COOPER NUCLEAR STATION
CONTRACT No. E-68-A

INTERNAL PIPING & STRUT ARRANGEMENT (CONDENSER SHELL 1A)

| DWG. EC93877SP-1A | REV. NO. |

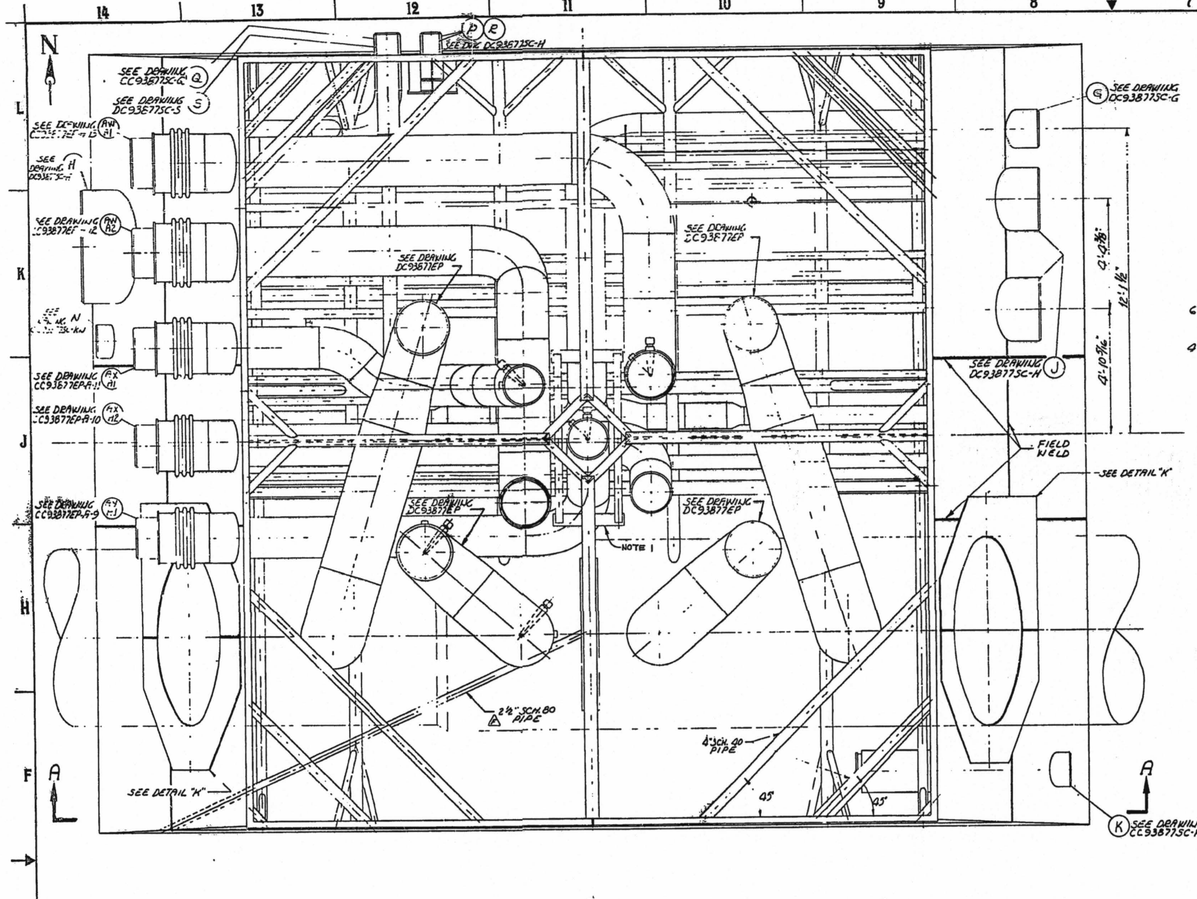
| ALT. | DATE | REVISION | BY | CK'D. |
|---|---|---|---|---|
| E | 7/17/74 | RELOCATED PIPE STIFFENER IN ZONE C-2. | D.D.C. | M.N.R. |
| F | 11-6-74 | ADDED PIPE STIFFENER TO HEATER SUPPORT ZONE H11 PER BER LTR DATED 5-23-69 | D.D.C. | M.N.R. |
| C | 4-17-69 | DELETED THE "STRAIGHT TUBES FROM EXTRACTION LINES" TO THE "U" TUBES AT EL. 913'-6" PER MFG. ECN 3-16-69 ADDED 3" SCH. 80 PIPE AT EL. 913'-6" PER B & R LETTER DATED 3-25-69 | F.M. | M.N.R. |

DETAIL "K"

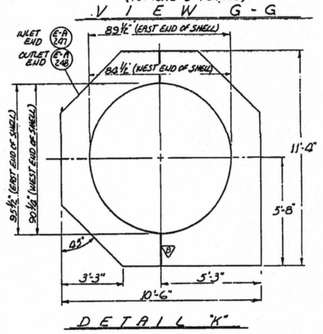
| ALT. | DATE | REVISION | BY | CK'D. |
|---|---|---|---|---|
| H | 2-6-69 | ADDED DETAIL "K" ADDED (2) 1"ø SS SPEC PLATES (SIMILAR TO DETAIL "J") DIRECTIONALLY FROM WEST SLOPE PLATE TO TUBE SUPPORT PLATE 3 REVISED STRUT ARRANGEMENT ABOVE ELEVATION 921'-0" PER B & R LETTER DATED 12-26-68 | F.M. | M.N.R. |
| B | 2-6-69 | ISSUE 2-1 - BOARD 1 OF WEB BRACE RELOCATED 3" PIPE (WAS 6" PIPE) ZONE B-4 - RELOCATED LUGS ZONE C-3 - REDESIGN 3" PIPE AND 6" PIPE ZONE E-1 - ADDED PIPE V-V ZONE F-4 - RELOCATED WELD IN DETAIL "K" ZONE J-3 - REVISED CURVATURE IN DETAIL "H" ADDED (10) COUPLINGS TO EXTRACTION PIPING (PLAN VIEW) PER B & R LTR. DATED 1-14-69 AND ADDI DATED 2-5-69 | F.M. | M.N.R. |
| D | 4-22-69 | ADDED DETAIL "J" ADDED DETAIL "H" REVISED DETAIL "K" | F.M. | M.N.R. |
